**Addendum No. 1**  
**March 6, 2025**

Project: Brandon Valley Middle School Addition  
Brandon, South Dakota  
Project #3090

Architect: Architecture Incorporated

**5.12**

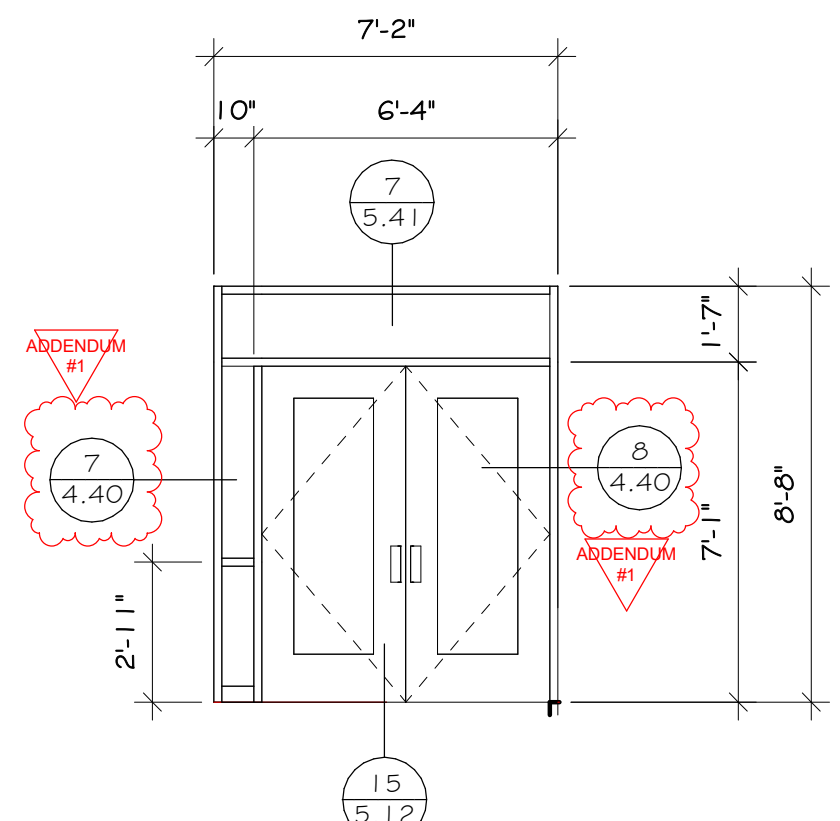
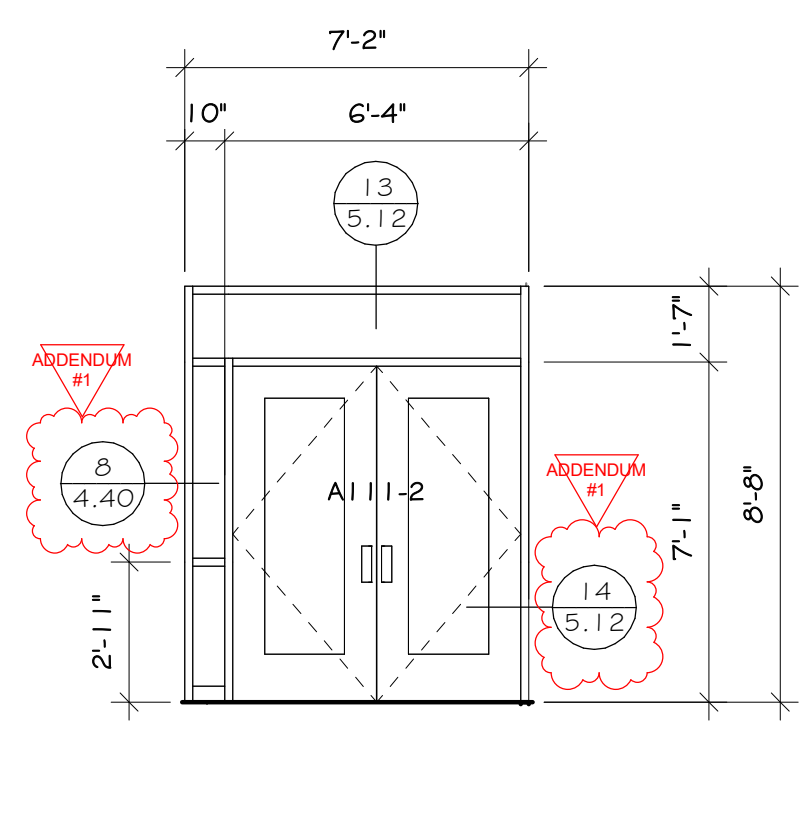
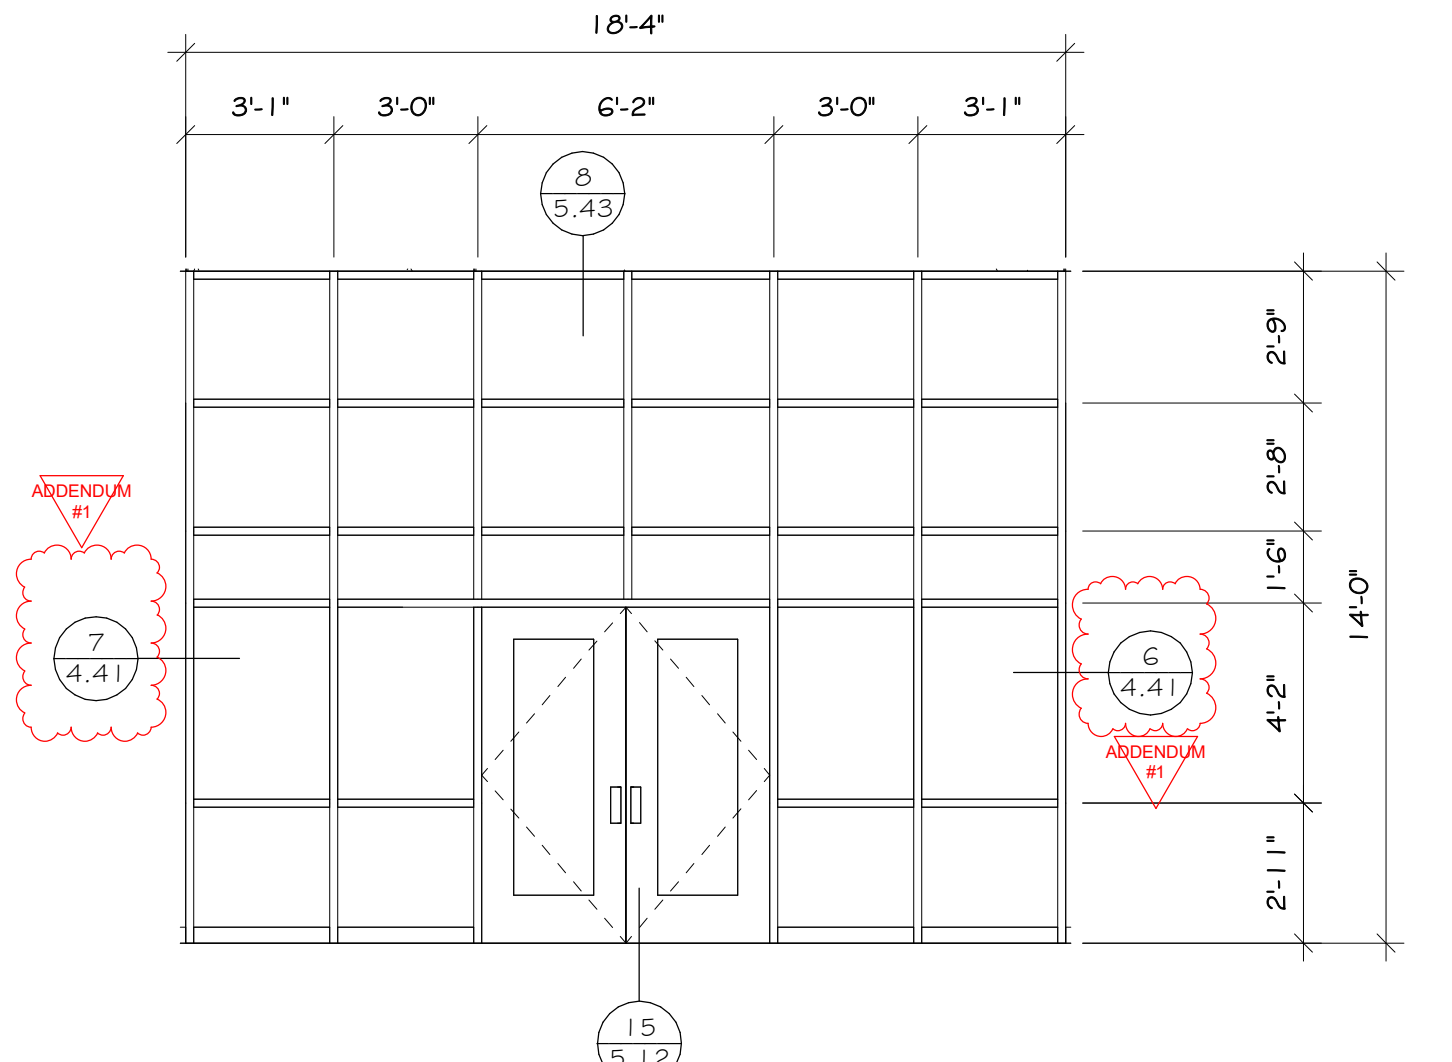
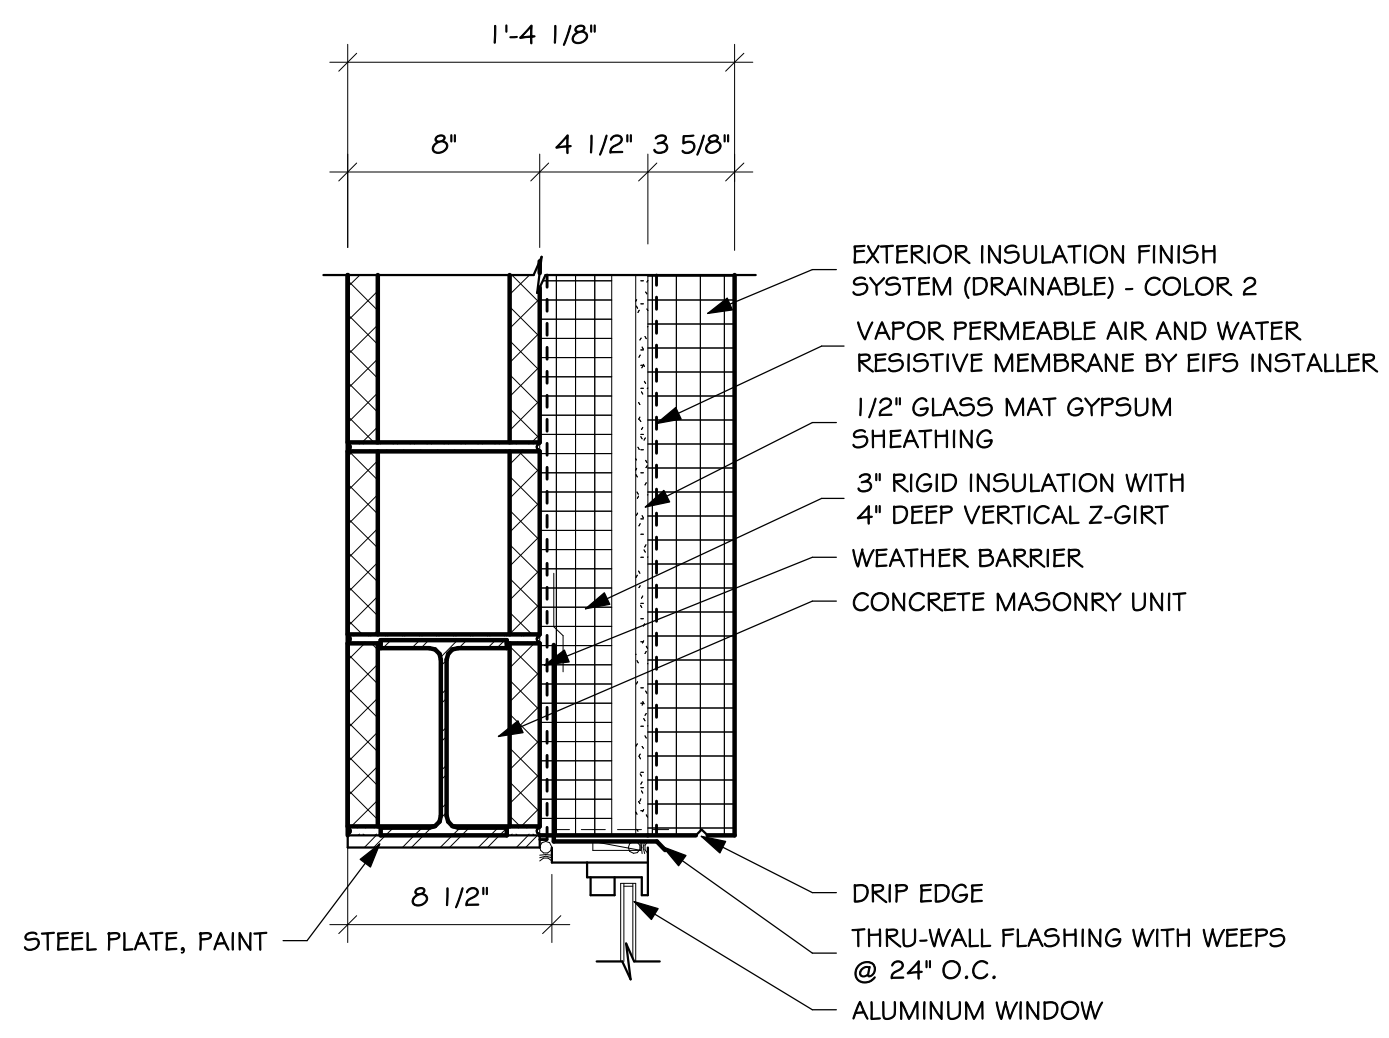
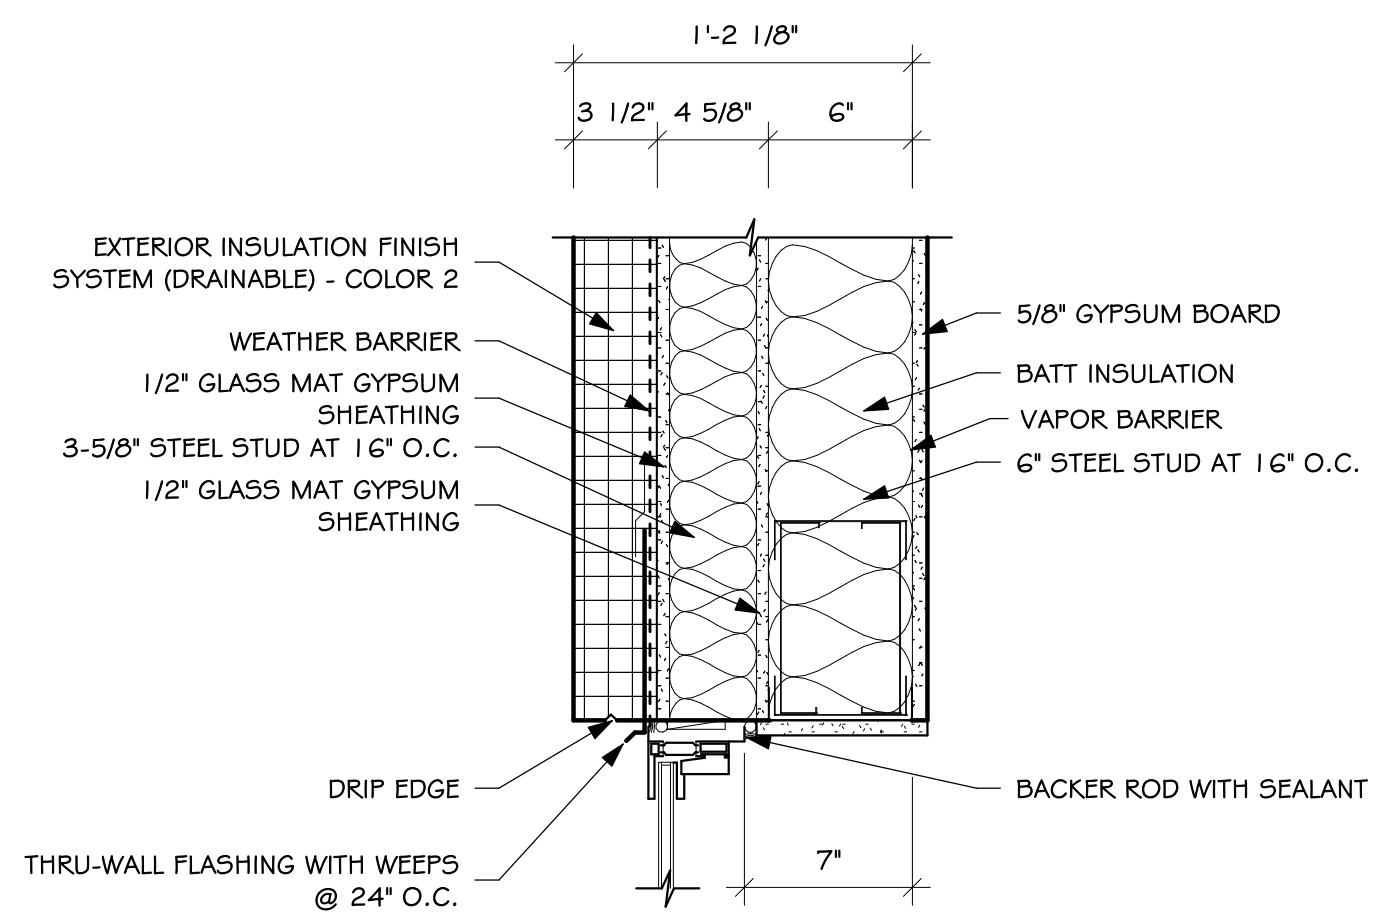
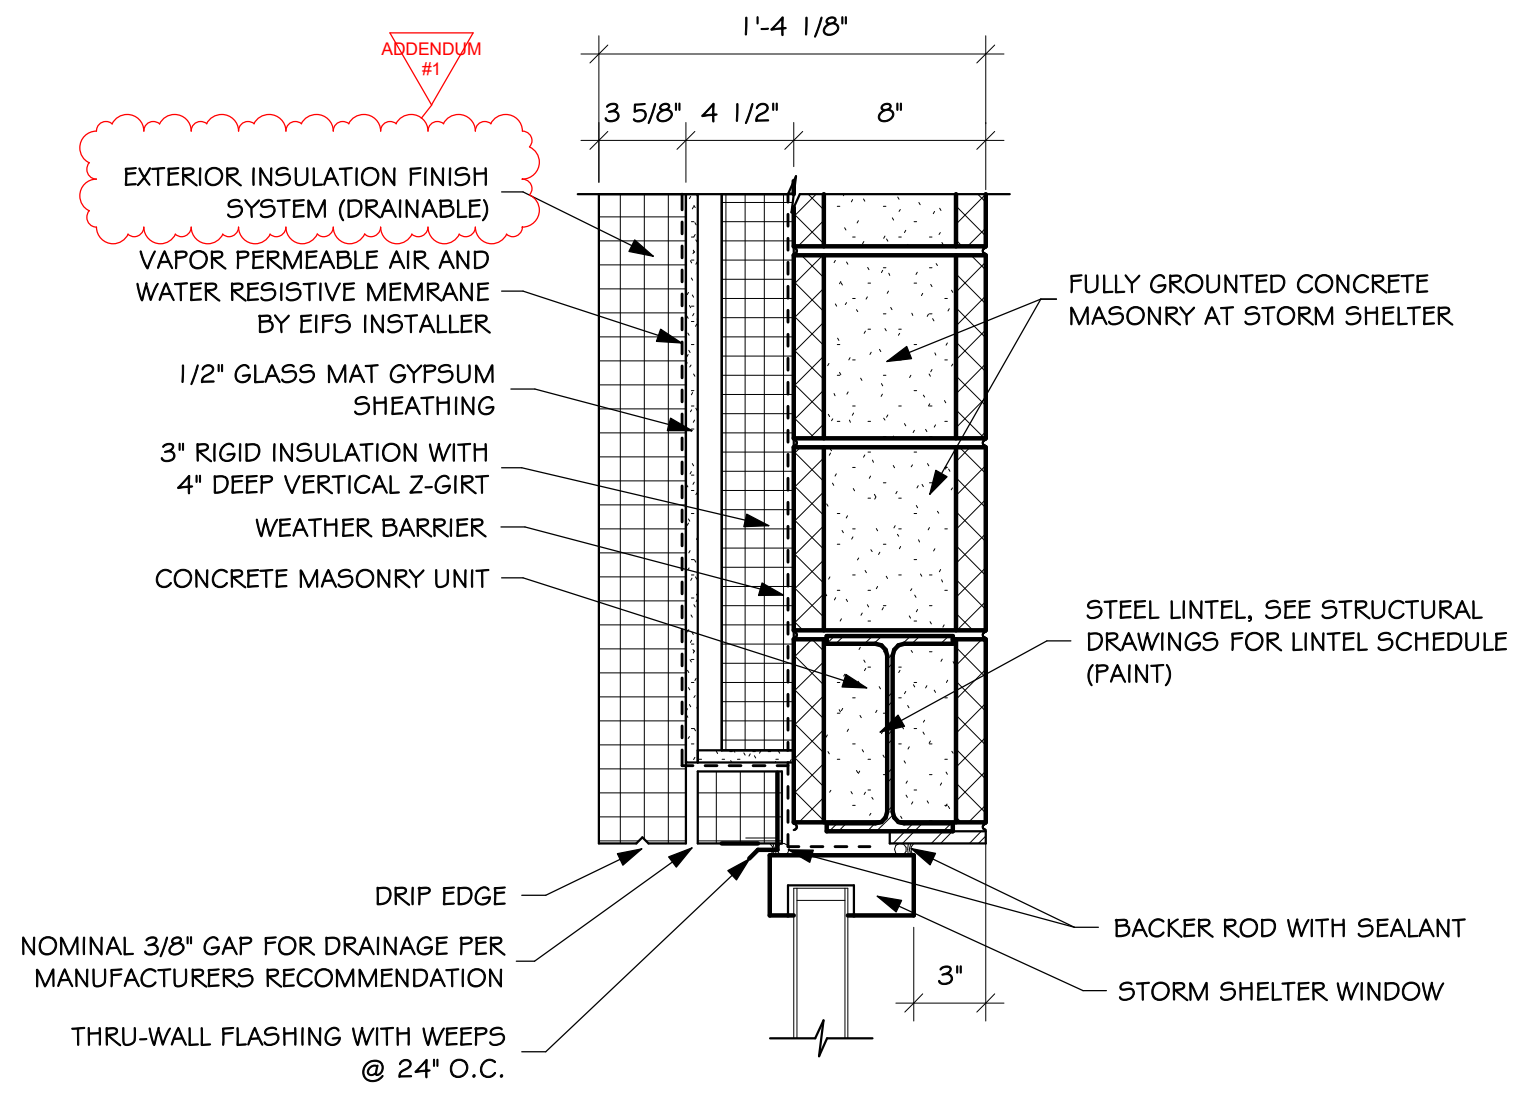
- 7) SHEET 5.12 – WINDOW/STOREFRONT ELEVATIONS AND DETAILS
  - a) CLARIFICATION: All exterior aluminum windows (Type A, B and C) shall have solid surface window sills per details 6/5.12, 9/5.12 and 12/5.12.

- b) Reference *revised* Sheet 5.12, dated 3-6-2025, attached to the end of this addendum for following modifications:
    - i) Added **Window Schedule**.

- ii) Added jamb detail reference for storefronts 1/5.12, 2/5.12 and 3/5.12.
    - iii) Head Detail 10/5.12: Single Score Burnished CMU note has been changed to “Exterior Finish Insulation System”.

- iv) Added clerestory window (Type D) jamb detail 16/5.12.
- 8) SHEET 5.50 – ROOF PLAN
  - a) Cut and patch a portion of existing roof where new relief hoods RH-1 and RH-2 will be installed. Reference mechanical drawings Sheet 8.52 and Sheet 8.53.

9.10

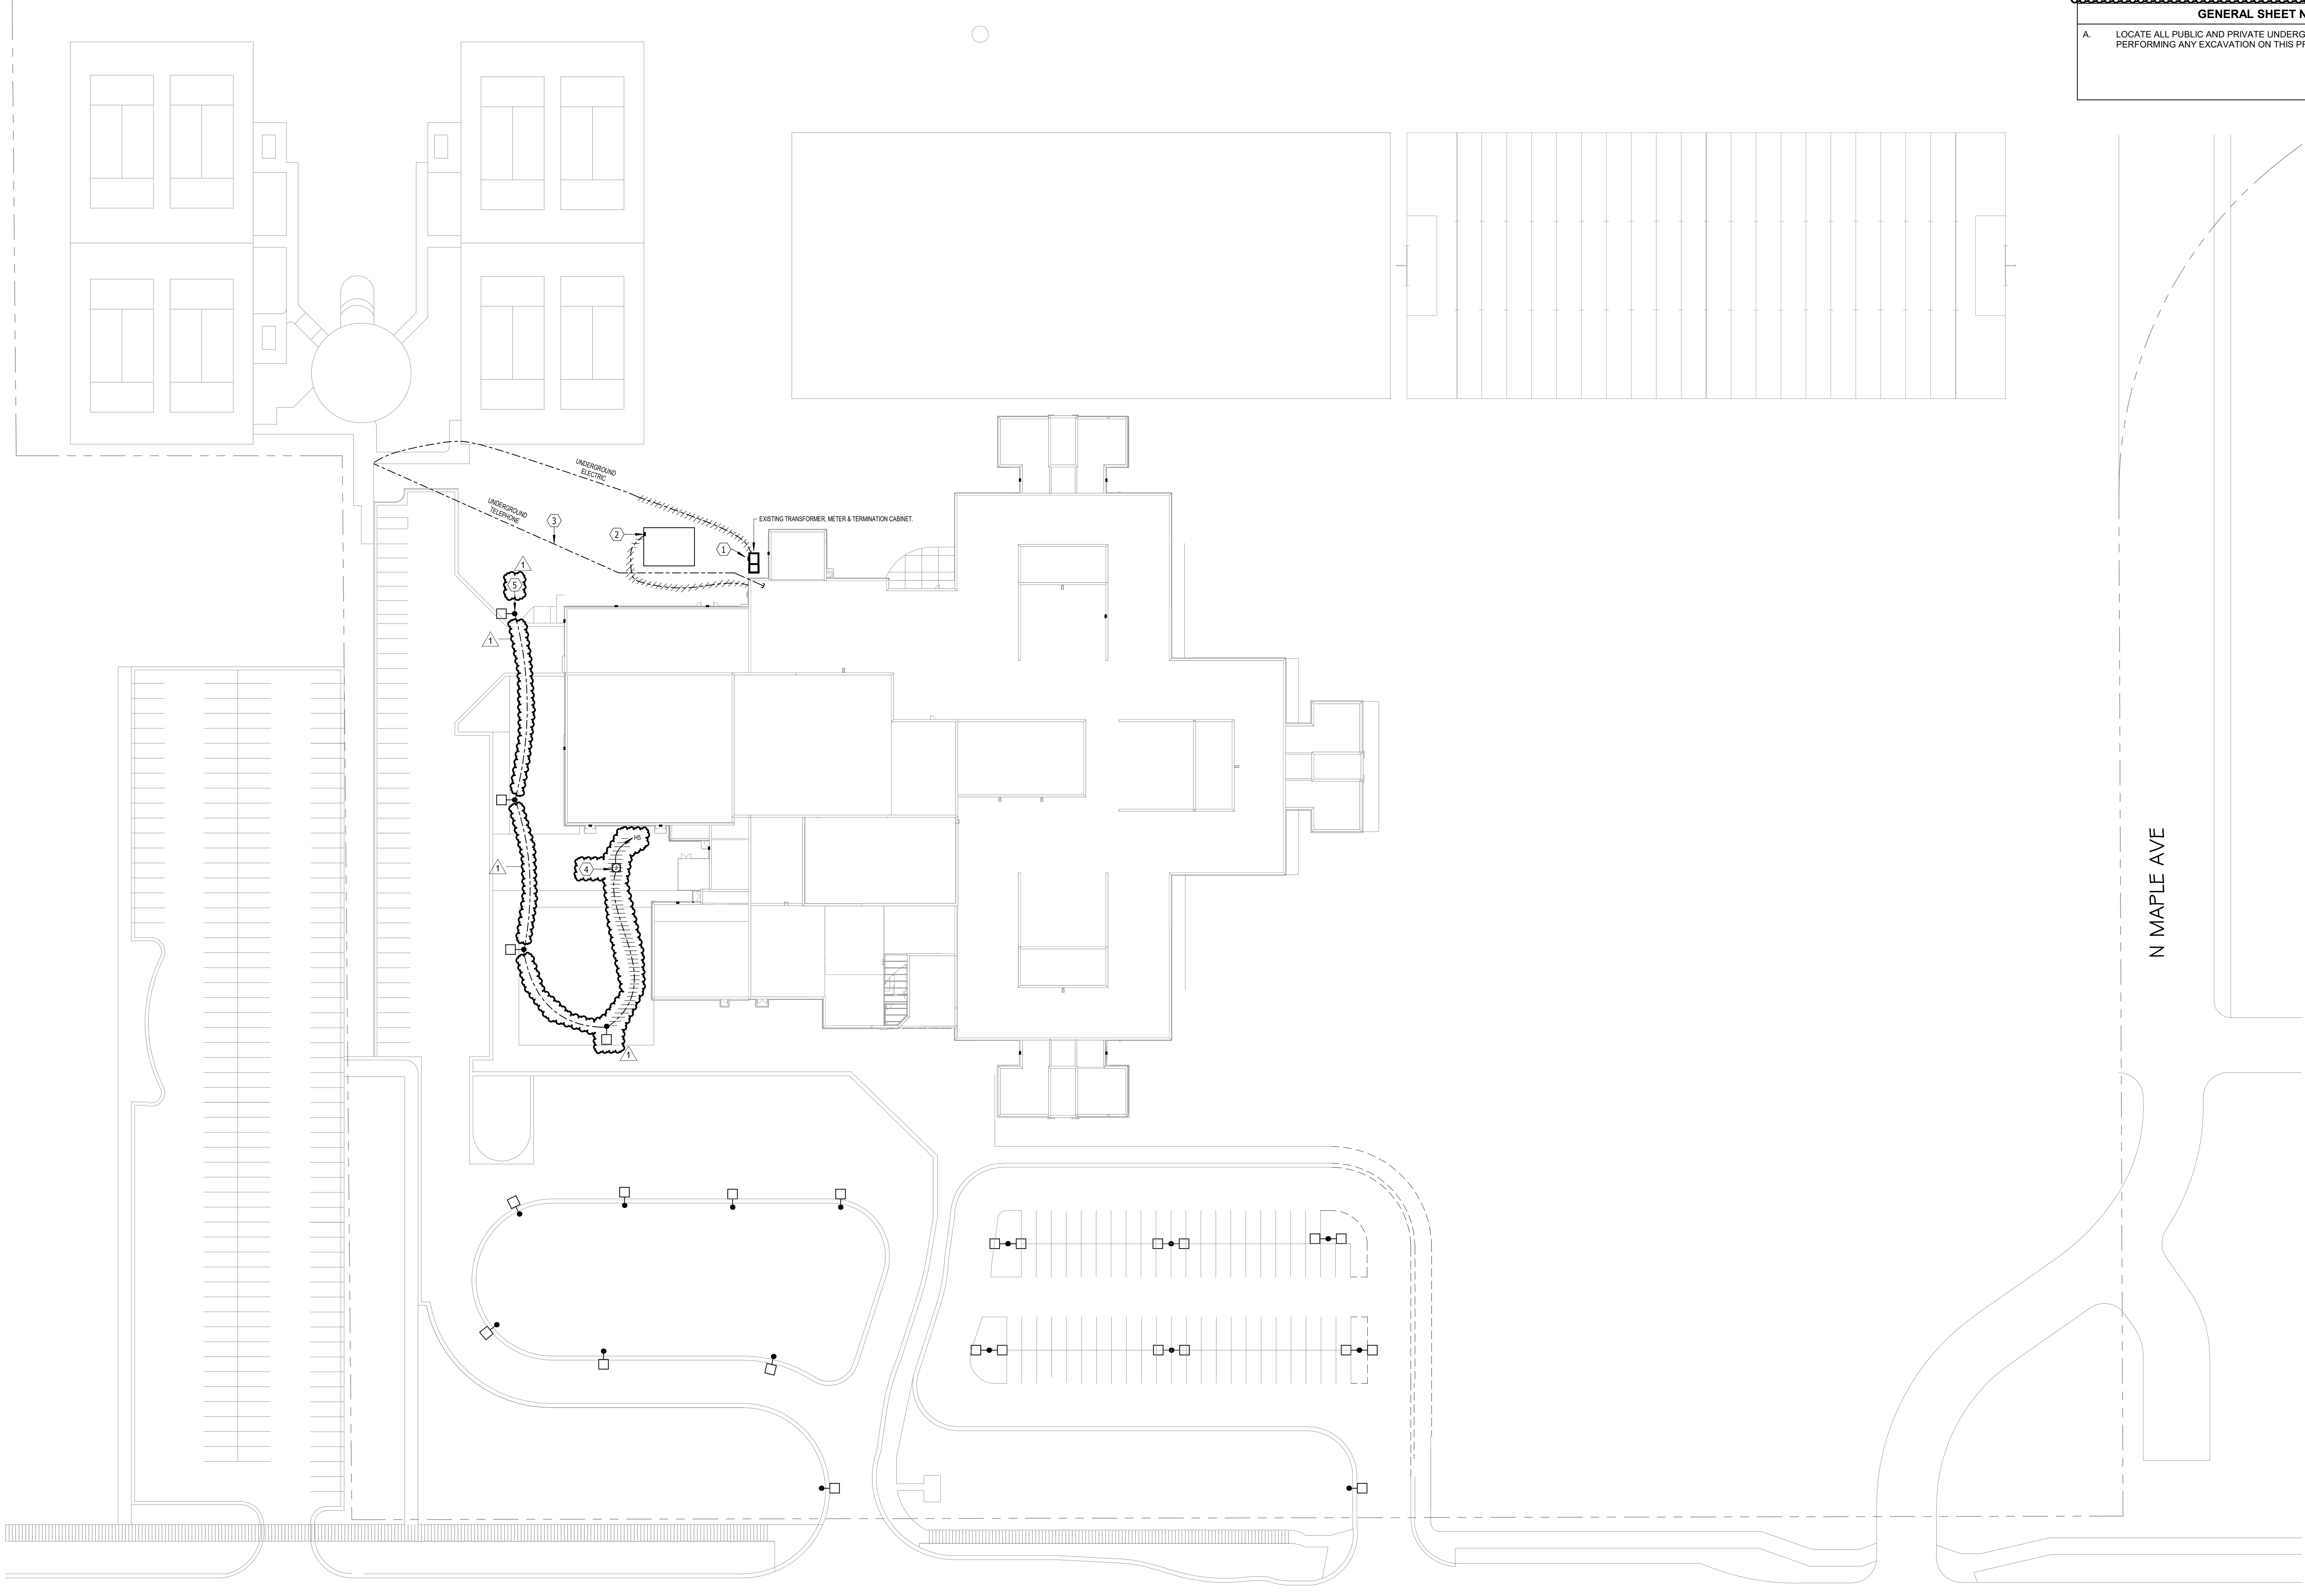
- 1) SHEET 9.10 – SITE DEMOLITION PLAN – ELECTRICAL
  - a) Add Electrical Note #4 that reads “EXISTING UNDERGROUND JUNCTION BOX TO BE DEMOLISHED.”.
  - b) Add Electrical Note #5 that reads “DEMO POLE BASE AND REPLACE WITH NEW. POLE BASE TO MATCH EXISTING. REMOVE AND REINSTALL POLE AND LIGHTING UNIT.”.

- c) Reference *revised* electrical drawing Sheet 9.10, revision dated 3-6-2025, attached to the end of this addendum for additional details associated with the pole lights.
